METROPOLITAN GOVERNMENT OF NASHVILLE AND DAVIDSON COUNTY

STAFF RECOMMENDATION
1807 4th Avenue North
April 16, 2014

Application: New construction - infill
District: Salemtown Neighborhood Conservation Zoning Overlay
Council District: 19
Map and Parcel Number: 08108028500
Applicant: Infill Development Services, LLC
Project Lead: Sean Alexander, sean.alexander@nashville.gov

<p>Description of Project: The applicant proposes to construct a new two-story two-family dwelling.</p> <p>Recommendation Summary: Staff recommends approval of the new building at 1807 4th Avenue North with the condition that specific window and door selections are approved by staff, finding that the proposal meets the guidelines for the Salemtown Neighborhood Conservation Zoning Overlay.</p>	<p>Attachments A: Photographs B: Site Plan D: Elevations</p>
--	--

Site Plan		H1
Date	4/3/14	
Drawn by	J. Feller	Scale 1/16" = 1'-0"

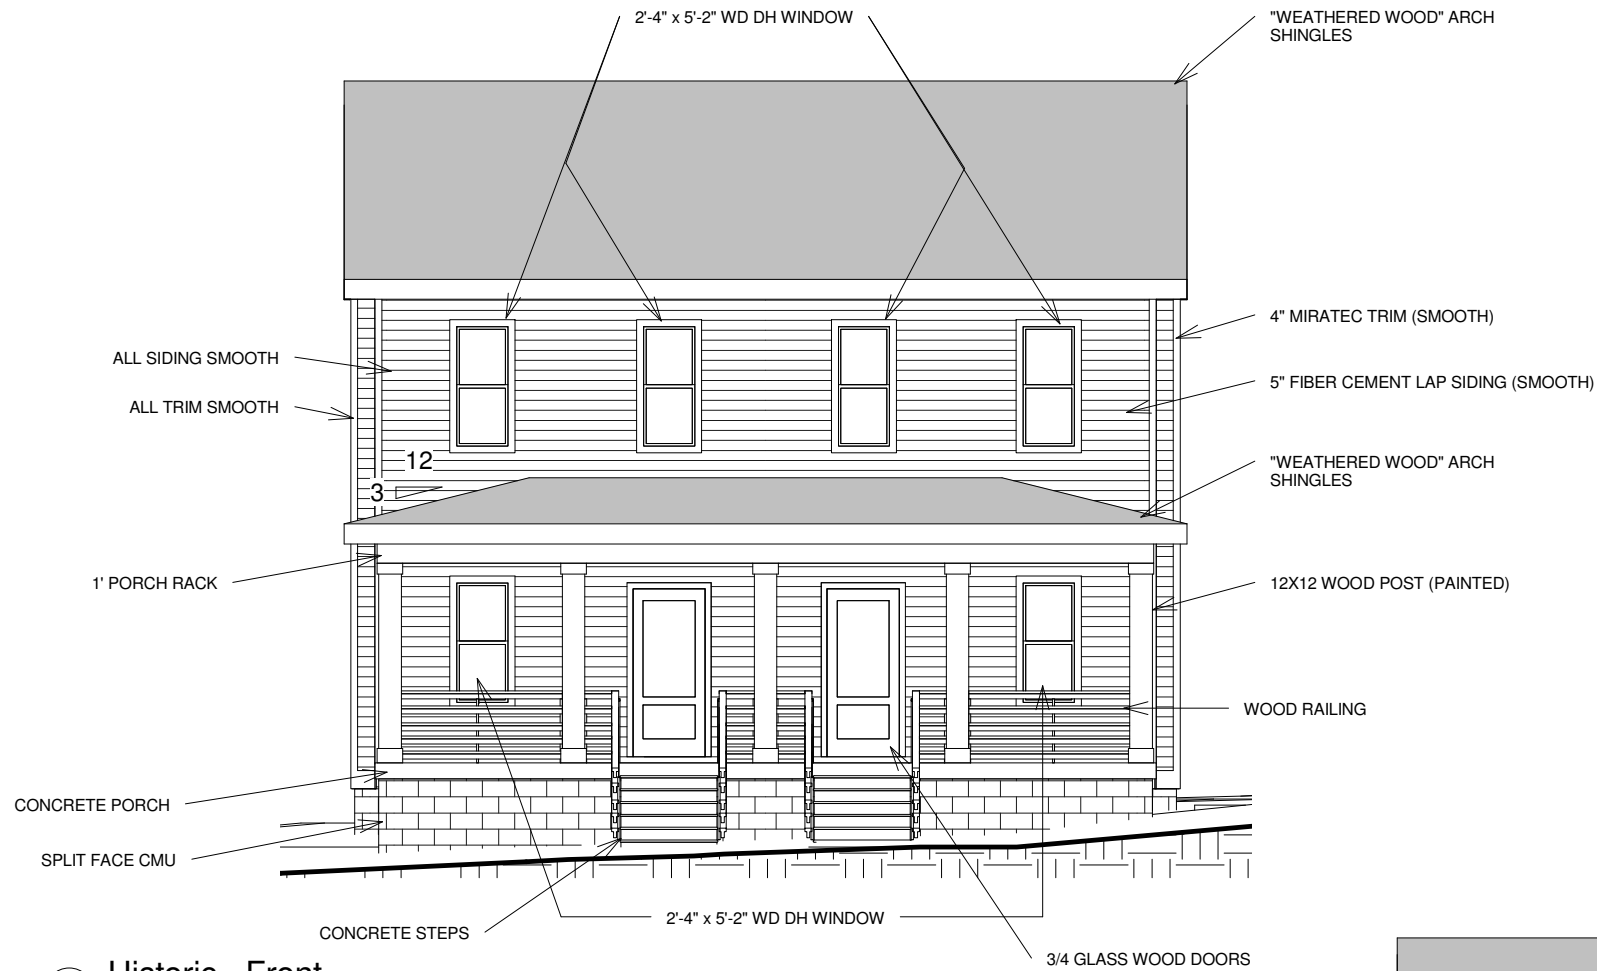
The new building will have a front setback of twenty-one feet (21'), which is the average of the front setbacks for the adjacent buildings. Both side setbacks will be approximately eight feet (8'). Staff finds that the setbacks of the new building will maintain the existing rhythm of spacing on the street, and that the project meets section II.B.1.c of the design guidelines.

The orientation of the new building will match other houses nearby. It will have a full-width front porch engaging the street with two walkways, one from each unit, that connect it to the sidewalk. At the rear of the lot there will be a pair of paved parking areas accessed from the alley. Staff finds that the project meets guideline II.B.1.f.

Elevations

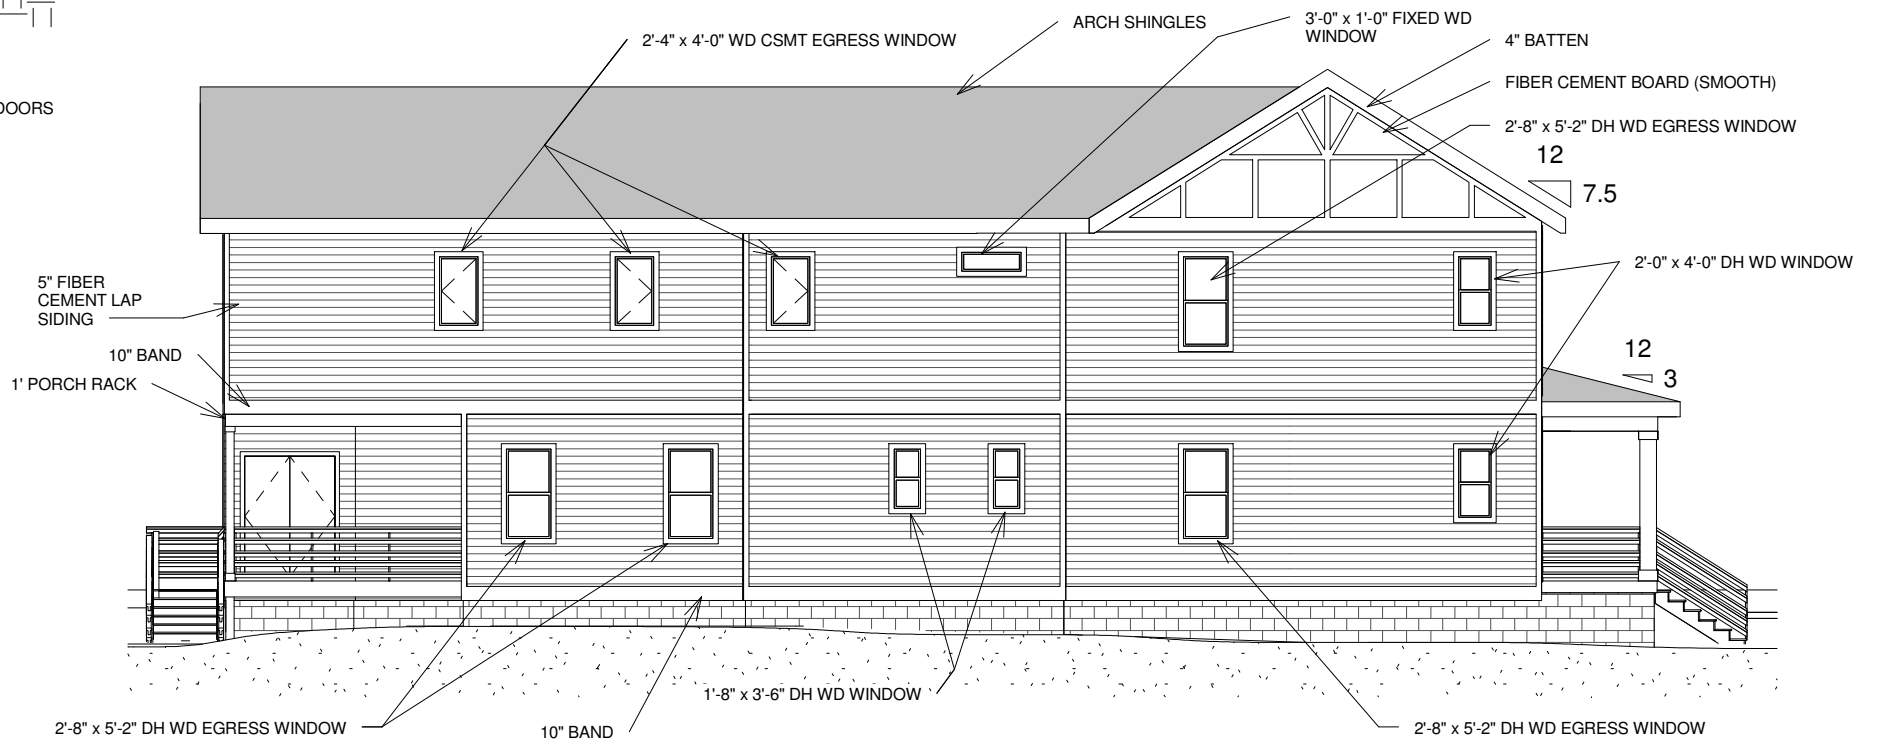
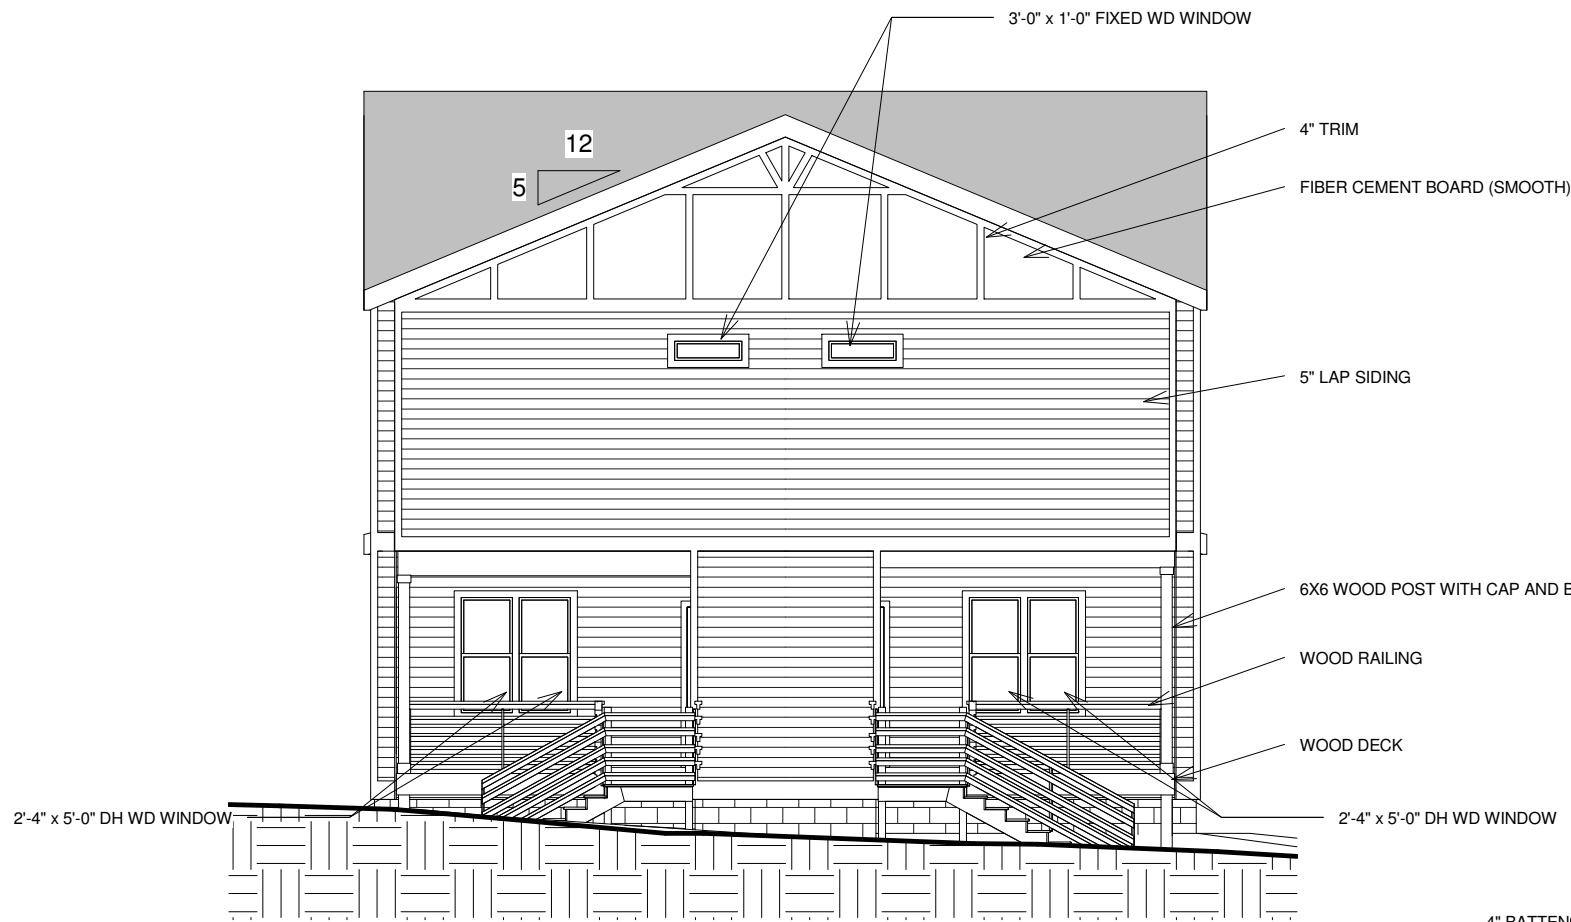
The new building will be two-stories tall with a side-gabled form, similar to the historic house at 1900 4th Avenue North. The lot has a slope which will be addressed by exposing four feet (4') of foundation on the left but only two feet (2') on the right. At the center the new building will have a roof ridge height of thirty-two feet (32') from grade, with an eave height of twenty-three feet (23'). The building will have a one-story porch with an eave height of twelve feet (12') at the center. The guidelines state that "where there is little historic context, existing construction may be used for context. Primary buildings should not be more than 35' tall." Because there is little historic context on this street, and because the height of the non-historic structures range between seventeen feet (17') and thirty-four feet (34'), staff finds that the proposed height meets the design guidelines.

The new building will be thirty-two feet, six inches (32'-6") wide for the front and rear sections, with a two feet wider (2') middle section. This central bump-out will provide articulation and help to break up the perceived massing of the building. Staff finds this width to match the surrounding context, with nearby, historic and non-historic houses ranging in width from twenty-four to thirty-six feet (24'- 36').

The new house will primarily be clad in smooth-face cement fiberboard with a five inch (5") reveal, with cement-fiber half-timbering in the gable fields. The trim will be a wood-composite and the porch columns will be wood. The foundation will be split-faced concrete block, and the roof will be asphalt shingles in a "weathered wood" color. The door will be wood and glass and the windows will be wood, but staff asks to approve the specific selections prior to purchase. The porch floor and stairs will be concrete. With the staff's final approval of the windows and doors, staff finds that the known materials meet Section II.B.1.d of the design guidelines.

The primary roof of the new building will be a side-oriented gable with a pitch of 7:12, with a 5:12 pitched gable extending toward the rear. The porch will have a hipped-roof with a pitch of 3:12. Staff finds that the roof forms of the new building will be compatible with those of surrounding historic houses and meet guideline II.B.1.e.

The windows on the proposed new house are all generally twice as tall as they are wide, thereby meeting the historic proportions of openings. There are no large expanses of wall space without a window or door opening. Staff finds the project's proportion and rhythm of openings to meet guideline II.B.1.g.

Recommendation: Staff recommends approval of the new building at 1807 4th Avenue North with the condition that specific window and door selections are approved by staff, finding that the proposal meets the guidelines for the Salemtown Neighborhood Conservation Zoning Overlay.

Elevations		H3
Date	4/3/14	
Drawn by	Author	Scale As indicated

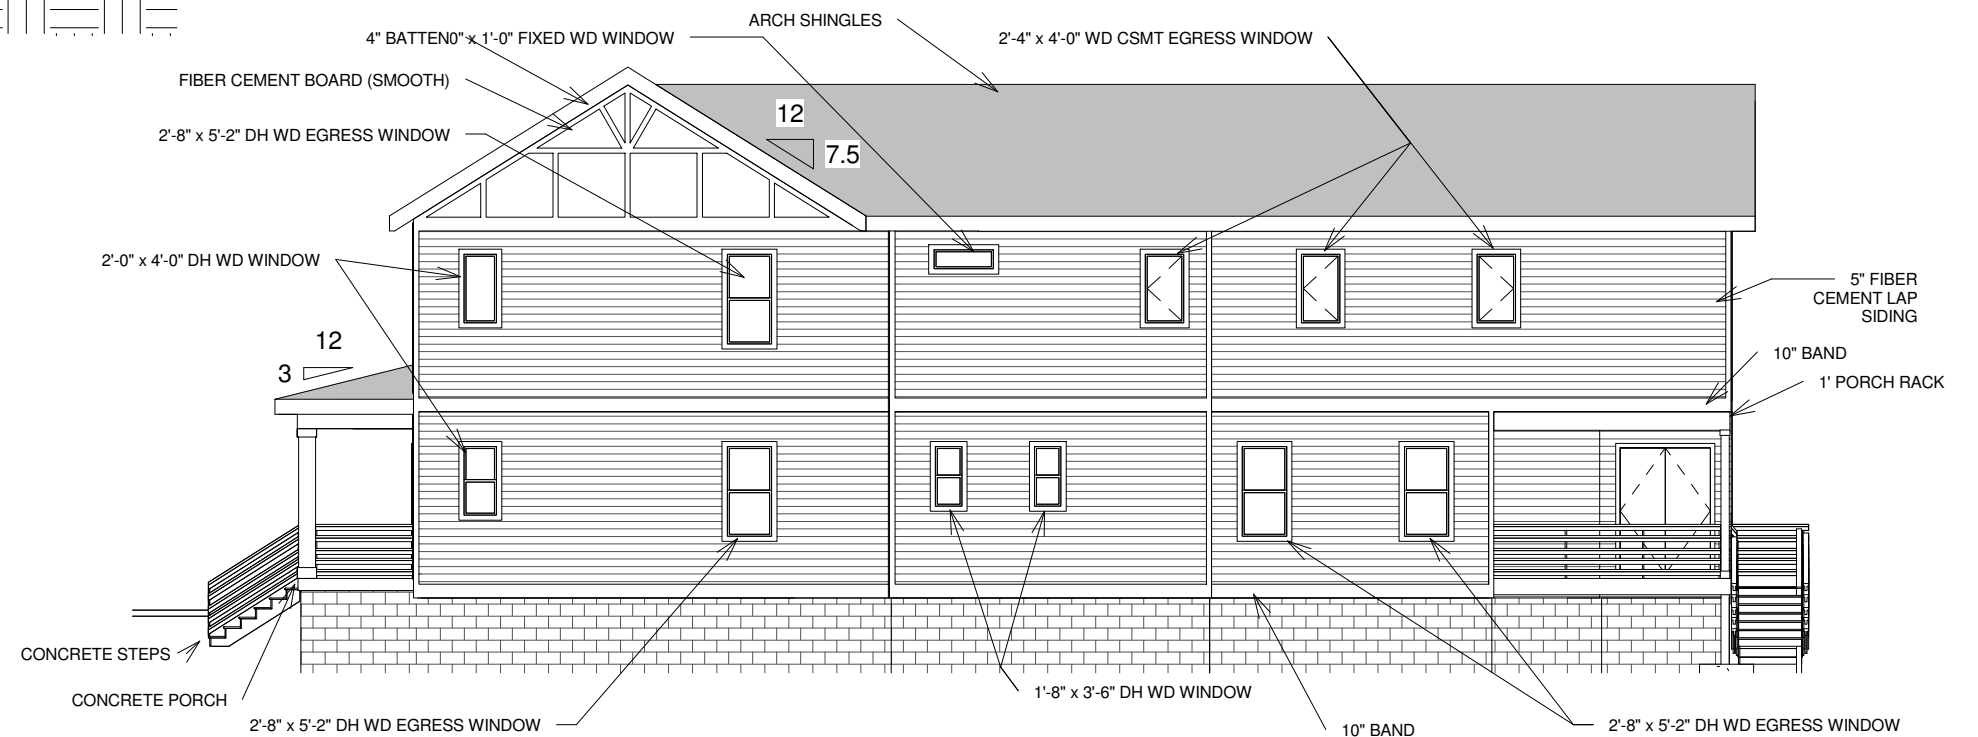
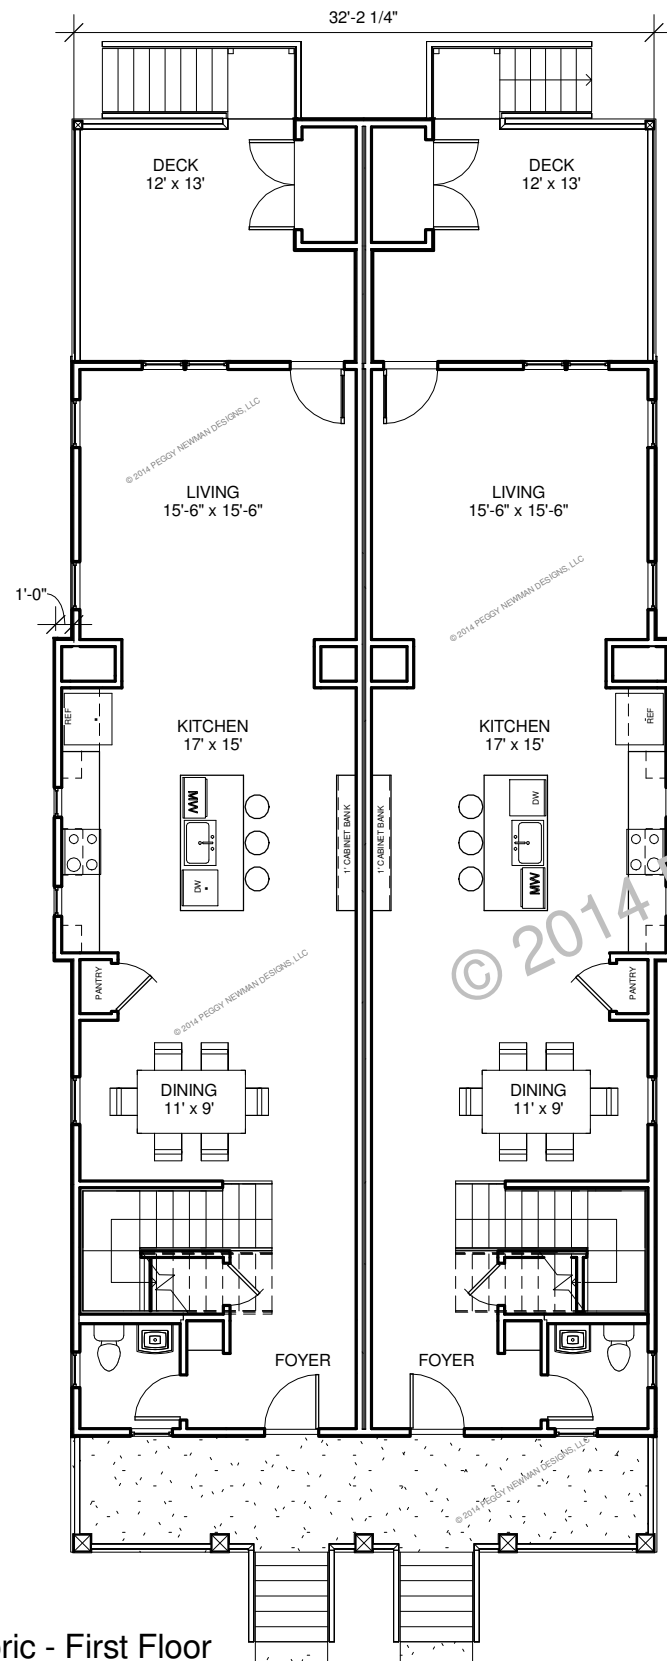
Appurtenances & Utilities: The location of the HVAC units will be on the side façades beyond the midpoint of the building. The project meets section II.B.1.i.
